RESPONSE TO CEC STAFF DATA REQUEST SET 2 (34-46)

Gilroy Backup Generating Facility (20-SPPE-03)

SUBMITTED TO: CALIFORNIA ENERGY COMMISSION
SUBMITTED BY: **Amazon Data Services, Inc.**

DRAWING NO:
G-103

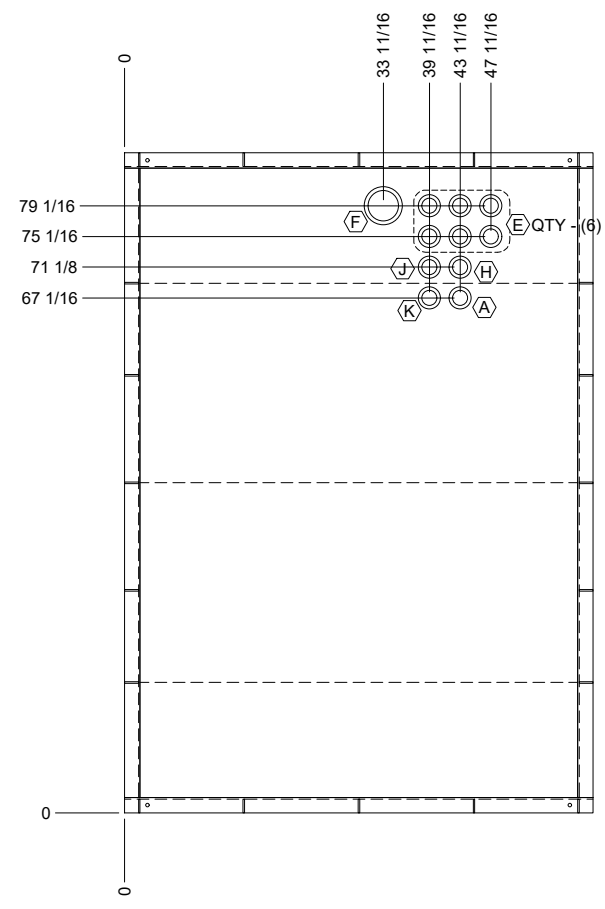
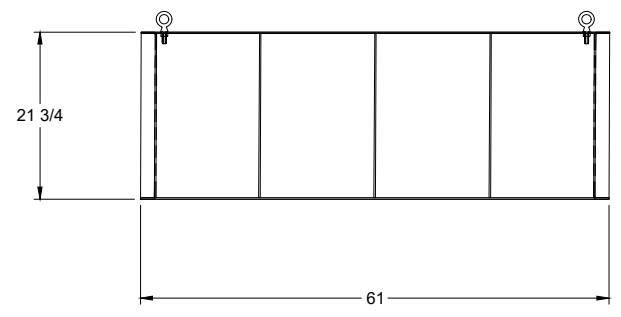
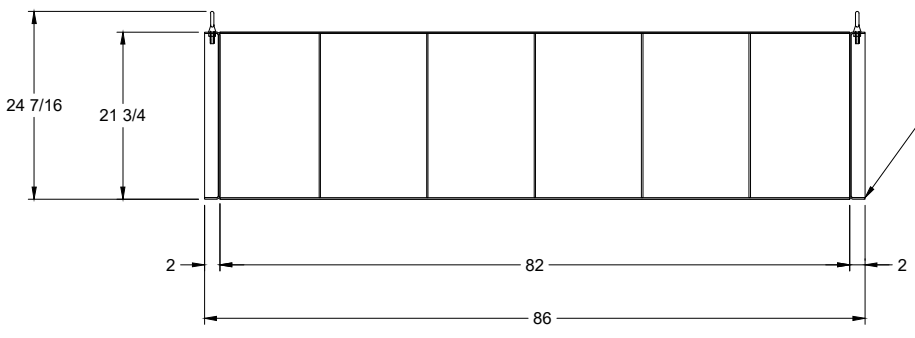
43. Please provide a schematic showing if the DEF is located in a secondary containment.

RESPONSE TO DATA REQUEST 43

See Attachment HAZ DR-43.
